CORPORATION OF THE TOWNSHIP OF ESQUIMALT

DRC Meeting: February 12, 2020

STAFF REPORT

SUBJECT: **Rezoning Application – 876 Dunsmuir Road**
PID 001-586-971, Lot 77, Section 11, Esquimalt District, Plan 265

1 Siteplan
 01 Scale: 1:100

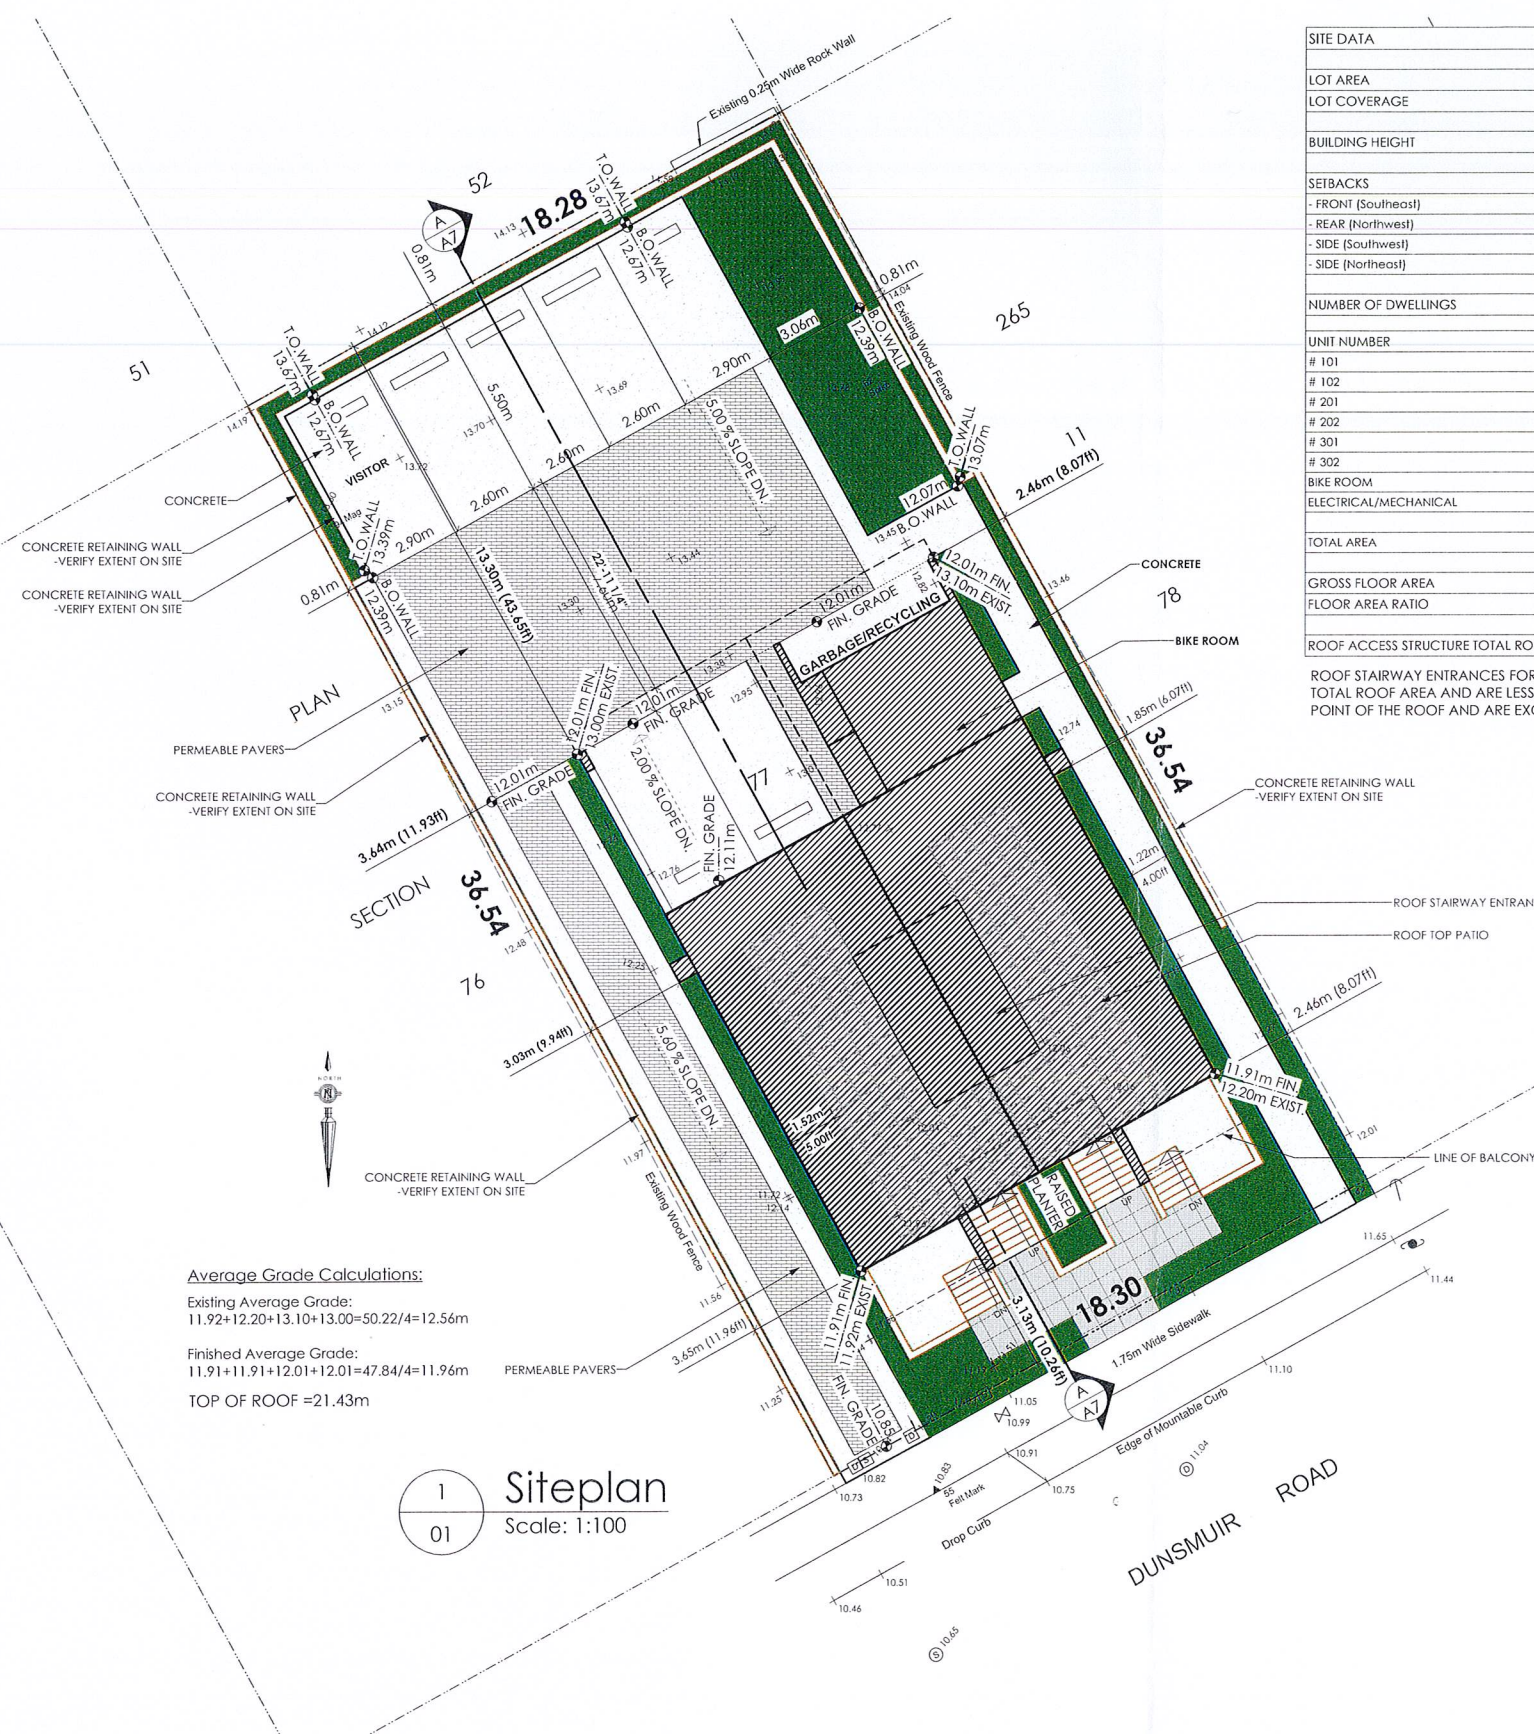
The proposed Lot Coverage at 37% is notably greater than the maximum 25% permitted in the RM-3 zone.

This proposal requires the significant reduction to the front setback to 3.0 metres (for the decks and stairs), from the 7.5 metre setback requirements of the RM-3 zone. Staff note that the proposed reduction to the Front Setback would position the building in a manner notably inconsistent with other buildings on this section of Dunsmuir Road. Adjacent buildings are setback at least 7.5 metres from the Dunsmuir Road Front Lot Line which would result in this building intruding into the established development pattern of this block. Proposed side setbacks are also reduced from the RM-3 zone standard in this proposal. Rear setback for the proposed building exceeds the established minimums primarily to accommodate all the required parking for the building resulting in a significant amount of the site being impermeable or having limited permeability.

Parking Bylaw 1992, No. 2011 requires the minimum width of a maneuvering aisle accessing a double bank of parking to be at least 7.6 metres where spaces are 2.6 metres wide. This standard is met in the proposed design but at a cost to permeable planting areas. Staff are of the opinion that consideration should be given to redesigning the parking area to accommodate sufficient planting area along to Rear Lot Line to support the inclusion of trees or hedging offering privacy and more substantial beautification of this space. The driveway is 3.0 metres wide and is located over a private easement serving the parcel to the northwest thereby predisposing the driveway to this side of the lot. Due to the depth of this lot, the fire department would not place a fire truck on the private property.

1 Section A-A
07 Scale: 1/4" = 1'-0"

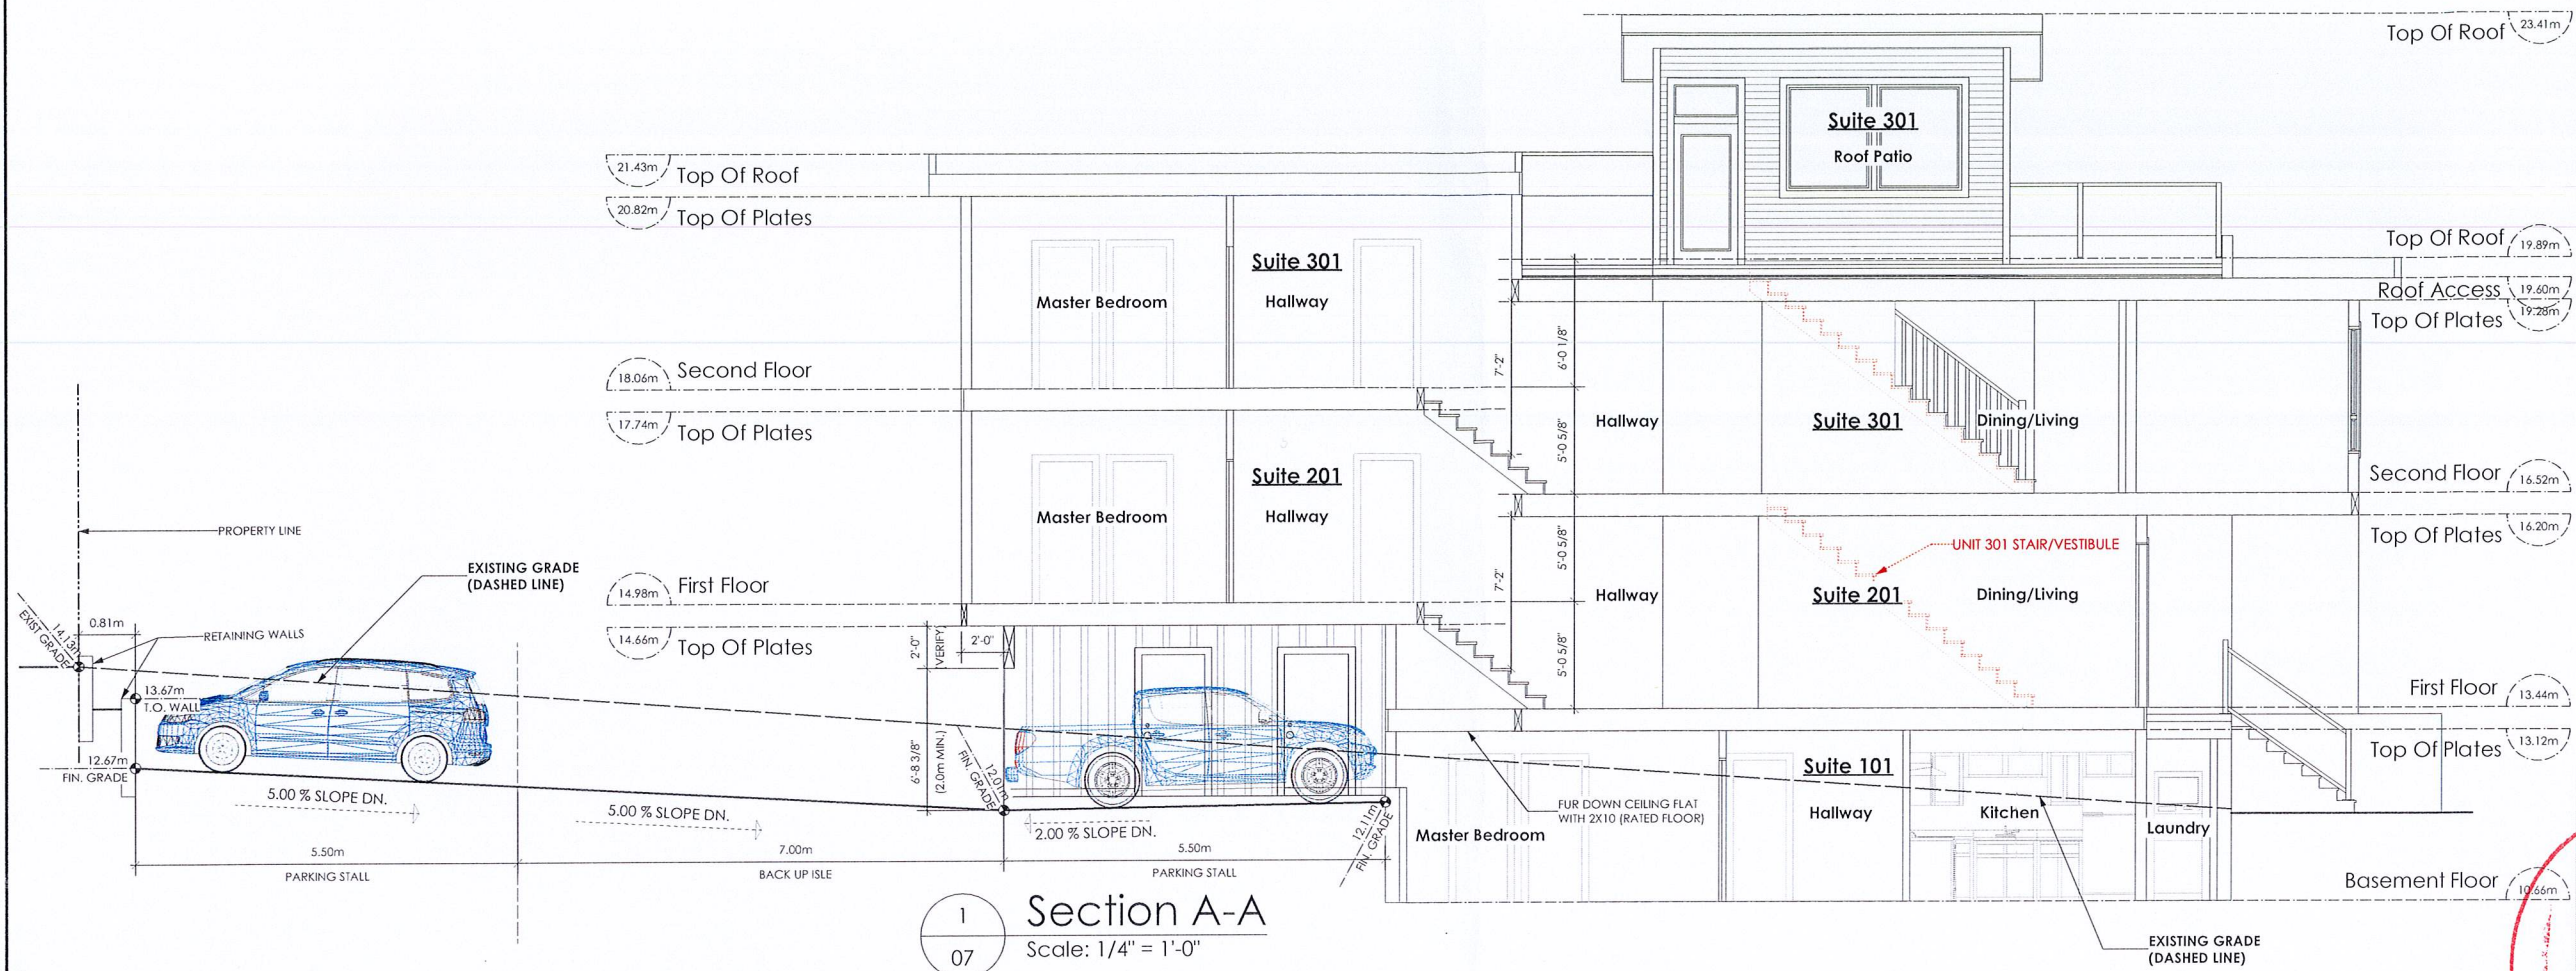
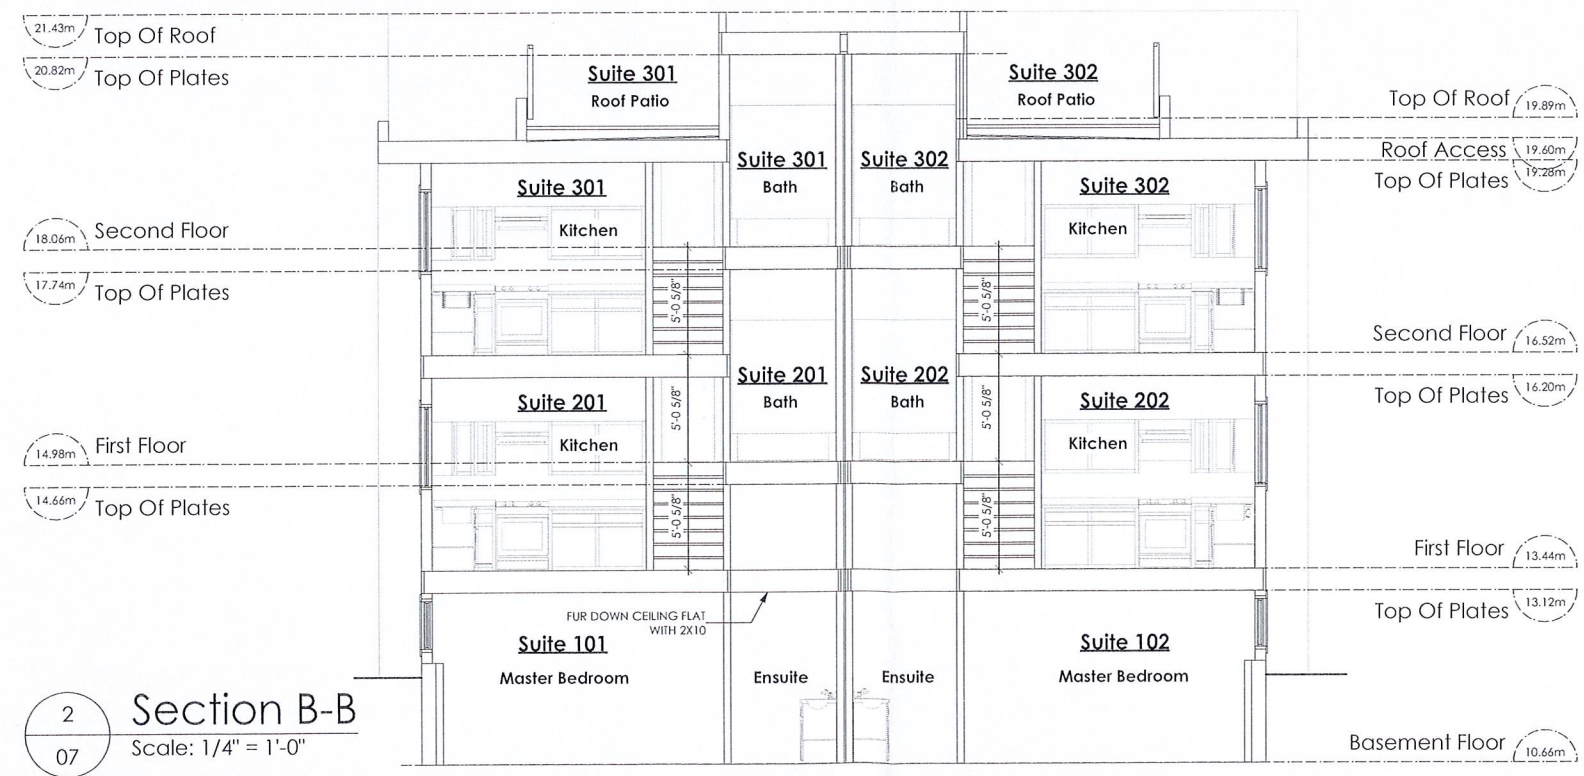
The height of the proposed building at 8.9 metres is just below the maximum 9.0 metres provided in the RM-3 zone. Both lower floor units are partially located below grade thereby exempting these spaces from the FAR calculation and mitigating the overall height of the building.

Staff note that a byproduct of this design approach is that grade level windows on both the southwest and northeast side elevations offer limited light penetration, particularly when considering the proposed landscaping abutting these openings and that there are no openings

along the rear wall of the lower floor units. The front [southeast] walls have both a glazed door and large window offering natural light into the lower floor units but direct light penetration is interrupted by the overhanging decks of the first storey units above.
